# Authorized Field Change

AFC 22903

**Subject:** Labels

Model: International<sup>®</sup> HV<sup>™</sup>, HX<sup>®</sup>, LT<sup>®</sup>, and RH<sup>™</sup> Series trucks

Figure 1. DEF Warning Lamp Label

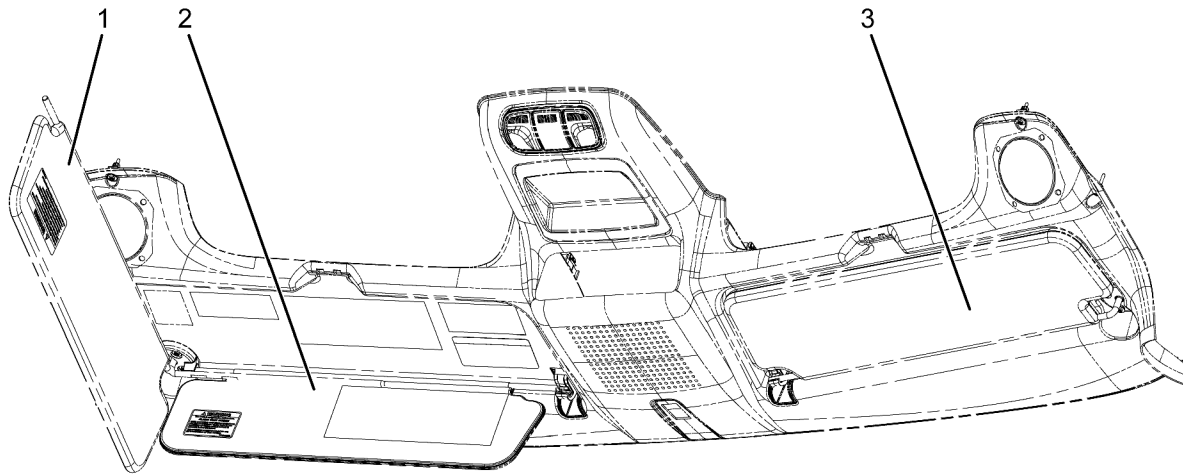
The Proposition 65 and/or DEF warning light label may not have been installed at time of vehicle manufacture.

5. With driver-side primary sun visor in closed or stowed position, inspect for presence of DEF warning light label (Figure 1).
  - a. Label is present; proceed to Step 7.
  - b. Label is not present; proceed to Step 6.

6. Install the DEF warning light label per Steps 6.a and 6.b.
  - a. Sitting in the driver seat, ensure the driver-side primary sun visor (Figure 2, Item 1) is in the closed or stowed position.
  - b. Remove backing from label, orient label so the driver can read from seated position, and press label onto visor. Proceed to Step 7.
7. Determine if the vehicle you are working on is equipped with a driver-side secondary sun visor (Figure 2, Item 2).
  - a. Secondary sun visor is not present; proceed to Step 8.
  - b. Secondary sun visor is present; proceed to Step 9.

**Figure 3. Proposition 65 Label**

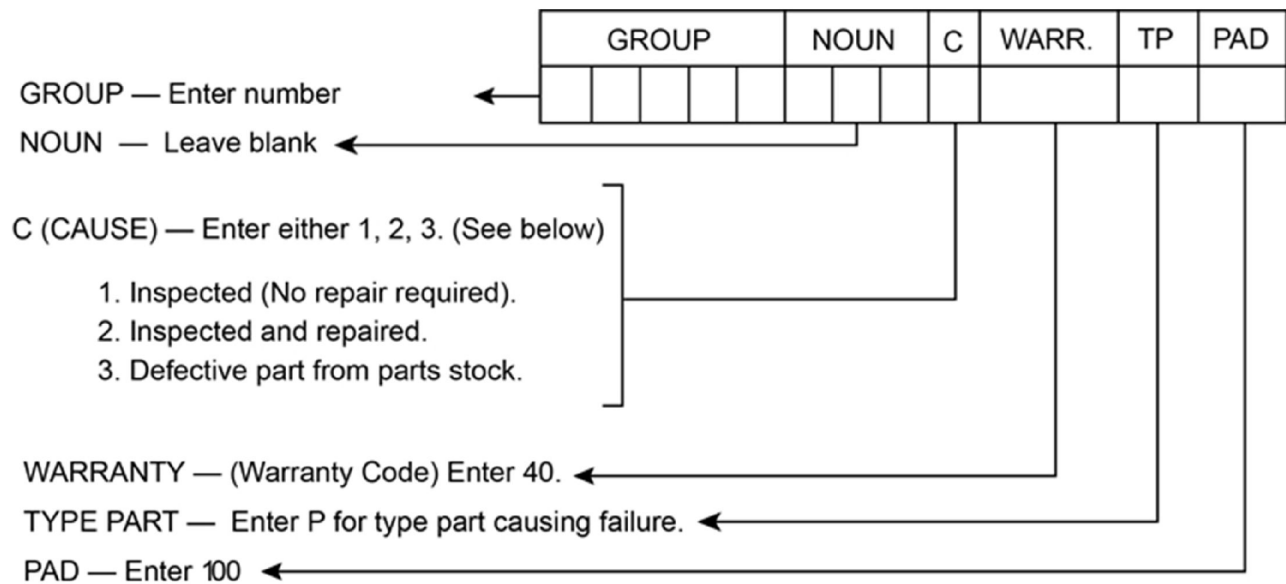
8. Install the Proposition 65 label (Figure 3) per Step 8.a and 8.b.
  - a. Sitting in the passenger seat, ensure the passenger-side sun visor (Figure 2, Item 3) is in the closed or stowed position.
  - b. Remove backing from label, orient label so the driver can read from seated position, and press label on the left side of passenger-side sun visor (Figure 2, Item 3). Proceed to Step 10.
9. Install the Proposition 65 label (Figure 3) per Step 9.a through 9.c.
  - a. Sitting in the driver seat, lower primary sun visor (Figure 2, Item 1) and then rotate visor towards driver-side door.
  - b. With secondary driver-side sun visor (Figure 2, Item 2) in the closed or stowed position, remove backing from label, orient label so the driver can read from seated position, and press label onto visor.
  - c. Close or stow driver-side primary sun visor. Proceed to Step 10.
10. Remove wheel chocks.
